**Service Bulletin**

**No. :** MZ09-023 **Date:** April 10, 2009

Model: CC4001

**Subject:** Change of the main microcomputer (software) (firmware improvement for an abnormal motor drive situation)

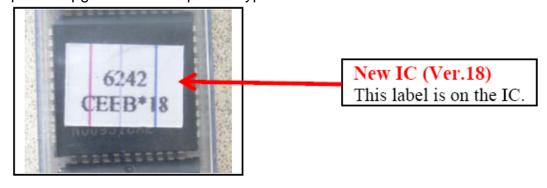
**Symptom:** There is a possibility of the loading motor turning and it will not stop, when an abnormality (soldering /short/opening etc.) was found in the motor drive circuit etc.

**Solution:** The security function has been improved by a program change in main microcomputer IC control.

Replace MICROPROCESSOR (O.T.P programmed) IC110 on the SERVO PWB.

Note: If you have stock of the old version IC (not having the following label), please upgrade to the improved type.
